***Design Review Board Case # 20-0003  
Blocks 4&5 – Carlyle Crossing Coordinated Sign Plan***

<b>Application</b>	<b>General Data</b>	
<b>Project Name:</b> Carlyle Crossing Coordinated Sign Plan Special Use Permit  <b>Location:</b> Blocks 4 & 5 – Eisenhower East 2410 and 2460 Mill Road  <b>Applicant:</b> HTC 4/5 Project Owner LLC	<b>DRB Date:</b>	February 25, 2021
	<b>Site Area:</b>	5.07 acres
	<b>Zone:</b>	CDD #2
	<b>Proposed Use:</b>	Residential, Retail, Parking
	<b>Gross Floor Area:</b>	1,021,711 sf
<b>Purpose of Application:</b> DRB review and approval of a Coordinated Sign Plan for the Carlyle Crossing mixed-use project. The plan proposes a program of design guidelines, principles, and regulations for signage to include street- and upper-level retail signage, residential identity signage, and other site signage.		
<b>Staff Reviewers:</b> Robert M. Kerns, AICP <a href="mailto:robert.kerns@alexandriava.gov">robert.kerns@alexandriava.gov</a> Thomas H. Canfield, AIA <a href="mailto:tom.canfield@alexandriava.gov">tom.canfield@alexandriava.gov</a> Nathan Imm <a href="mailto:nathan.imm@alexandriava.gov">nathan.imm@alexandriava.gov</a> Carson Lucarelli <a href="mailto:carson.lucarell

**Figure Above:** With the Potomac Yard CSP SUP (SUP#2020-00043), a logo was also used to reinforce the use/tenant of the space.

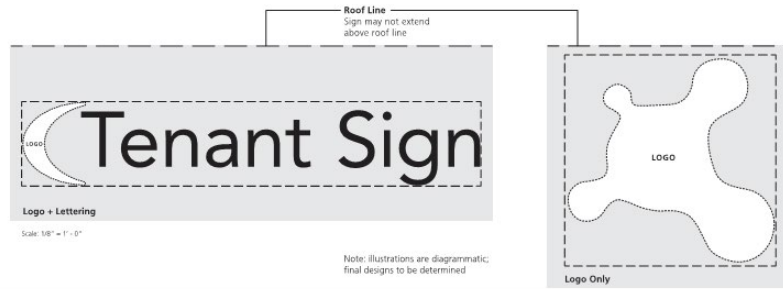
Staff find that the pin-mounted signage included with in the submission scales more elegantly with the building and its architectural elements. The unique branded image above the lettering also relates to the signage for same at the pedestrian entrance of building. As such, these images and letters help create both a unique sense of place that ties the building to the greater development, while simultaneously marketing the site from both near and afar. The design solutions proposed on the buildings are appropriate, however Staff do not believe the design precedent provided in the sign guidelines and shown immediately below would be appropriate for inclusion. The

**Figure Above:** Proposed Signage and Branding Logo for Boutique Tower

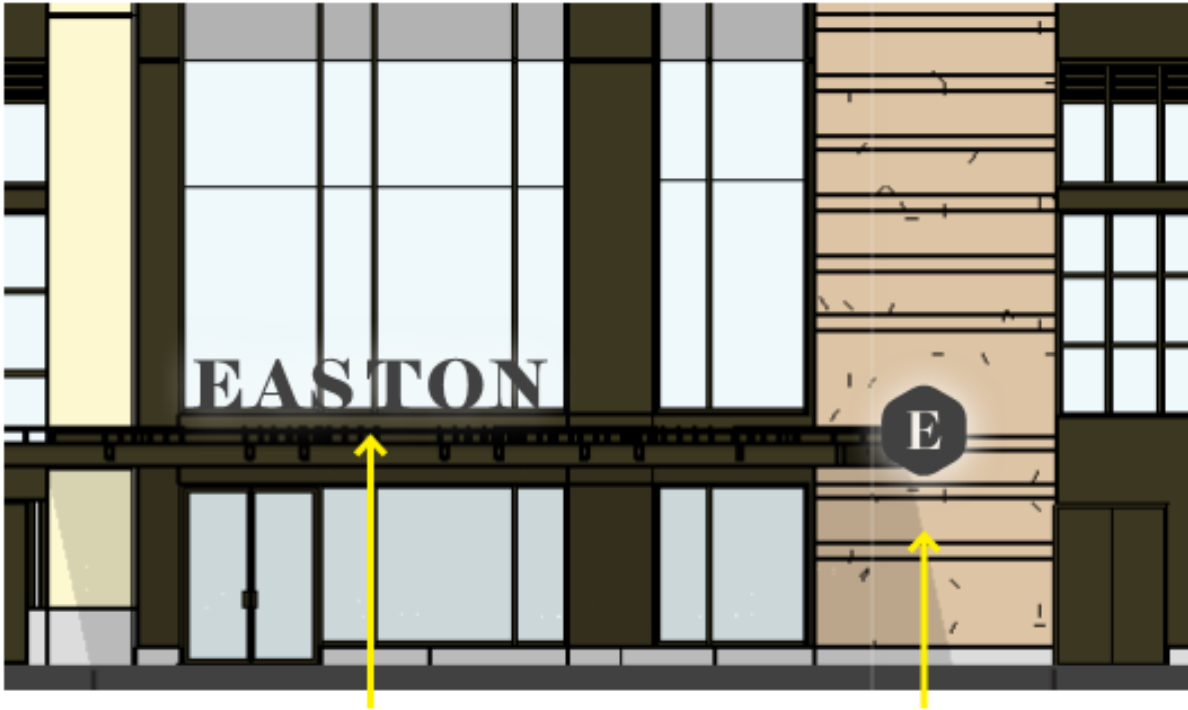
background does not fit with the architectural aesthetic that was otherwise been developed for the building .
